GENERAL INFORMATION

Applicant:	Lifespace Communities Inc. DBA Friendship Village of Bloomington
Location:	8100 Highwood Drive
Request:	Major Revision to Final Development Plans to modify the size and footprint of an approved but not yet constructed five-story, independent senior living building from 98 units to 93 units while preserving existing townhomes.
Existing Land Use:	Office (vacant), residential care facility, multiple-family and two-family (senior living) dwellings; zoned RM-24(PD) Multiple-Family Residential (Planned Development)
Surrounding Land Use and Zoning:	North – Freeway I-494 right-of-way South – Tierney's Woods Park; zoned SC East – Single-family residential; zoned R-1(PD) West – Trunk Highway 169 right-of-way
Comprehensive Plan Designation:	High Density Residential

Figure 1 – Residential Building Footprint Comparison

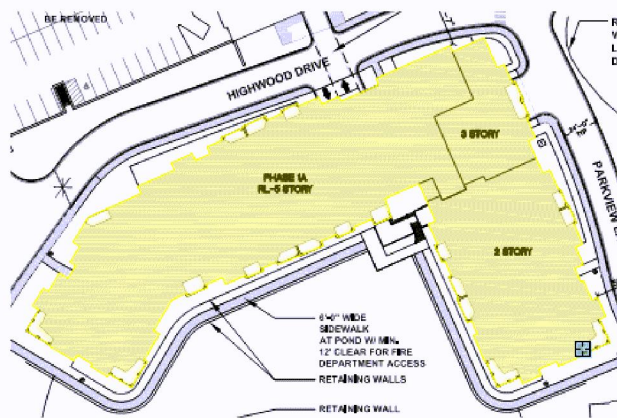
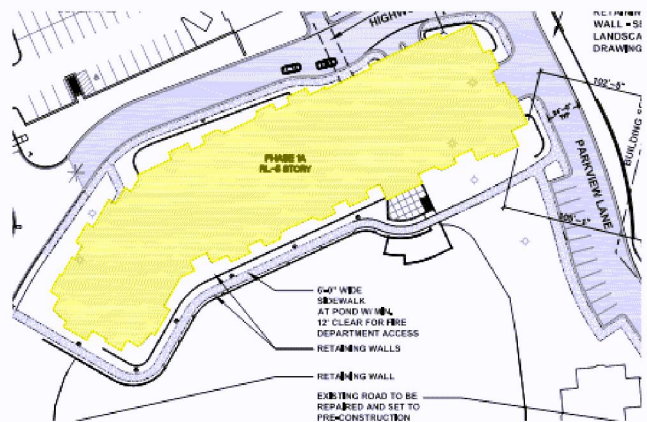
The senior living building footprint would be reduced from approximately 44,380 square feet (including balcony areas) to approximately 33,065 square feet, representing a 25.5 percent reduction. Figure 1 compares the approved building footprint against the revised building footprint presented in the subject application. The overall residential building floor area is reduced from 166,922 square feet (excluding garage area) to 156,000 square feet. The building footprint revision removes the eastern wing of the building, which is the two-story portion in closer proximity to the adjacent single-family residential subdivision (Tierney's Woods)

The previously approved residential building is located 50 feet from the single-family residential properties, whereas the revised residential building is located 93.8 feet from the abutting single-family properties. While the building footprint is reduced by 25 percent, the unit count is only reduced by five due to a height increase of a portion of the building (13.4 percent) from three stories to five stories. Table 1 provides a breakdown of the unit quantities and types on each floor of the

Figure 3 – Wetland Impacts Comparison

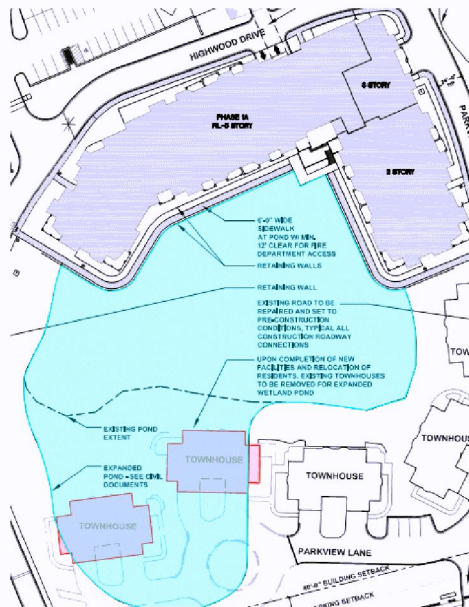
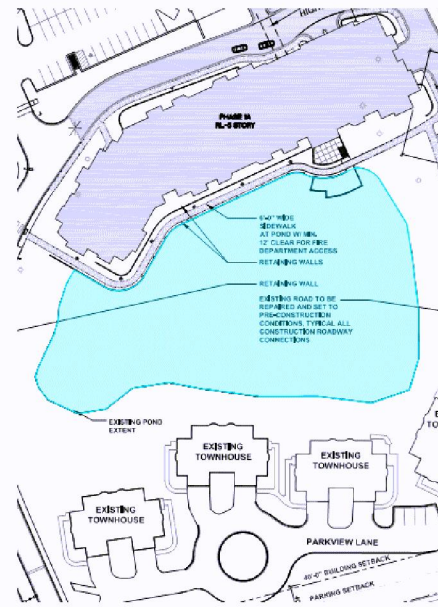
The wetland impacts associated with the revised site plan are less from an overall disturbance and intrusion standpoint. Although, the pond surface area is reduced with the revised site plan. Figure 3 shows a pond comparison between the approved site plan and revised site plan. The existing pond size is 82,621 square feet. The resulting pond size on the approved plan (Case #PL2017-250) is 77,092 square feet (93.3 percent of original size), whereas the revised site plan pond size is 60,506 square feet (73.2 percent of original size). The revised site plan retains four townhome units, whereas the approved plan includes the removal of these townhomes for the pond expansion. As part of the 2018 approvals, a Wetland Replacement Plan was approved which included the procurement of wetland bank credits under the procedures established in the Wetland Conservation Act (WCA). The wetland credits have been obtained by the applicant.

Figure 4 – New Surface Parking Areas

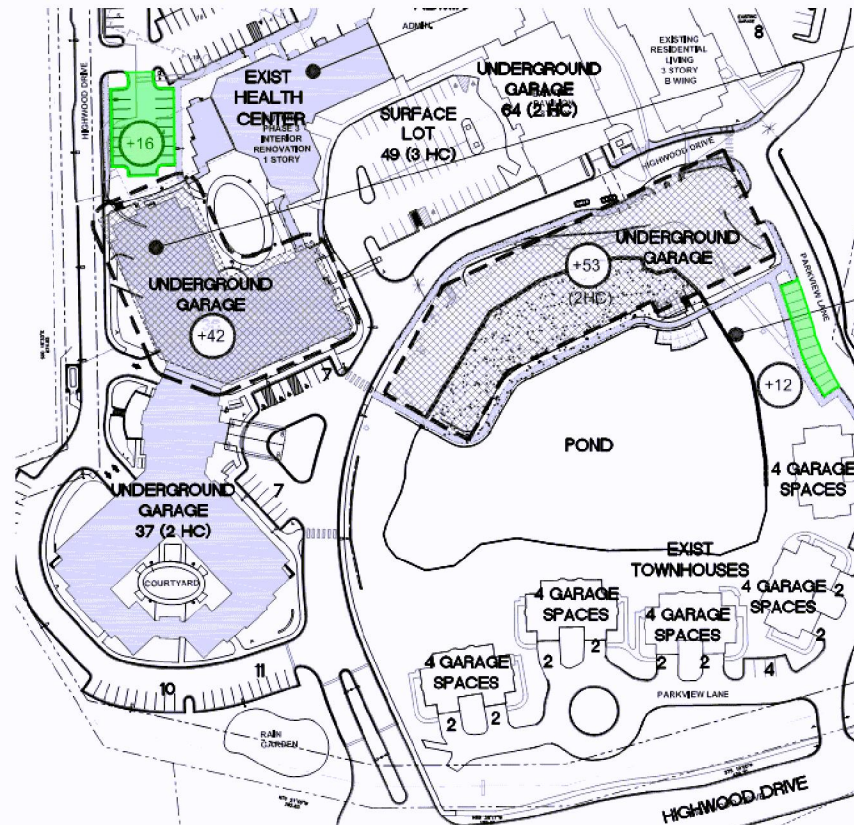
Two additional surface parking areas are proposed as part of the revised site plan. Figure 4 highlights the location of the new parking areas, totaling 28 surface parking stalls. 22 parking stalls located along the western side boundary along Trunk Highway 169 right-of-way are proposed to be

removed from the approved site plan, and additional parking stalls are added in a few locations through utilizing additional available land area. The result of the proposed parking changes increases surface parking from 284 to 302 spaces, decreases underground garage parking from 233 to 230 spaces, and increases total site parking from 226 to 233 spaces.
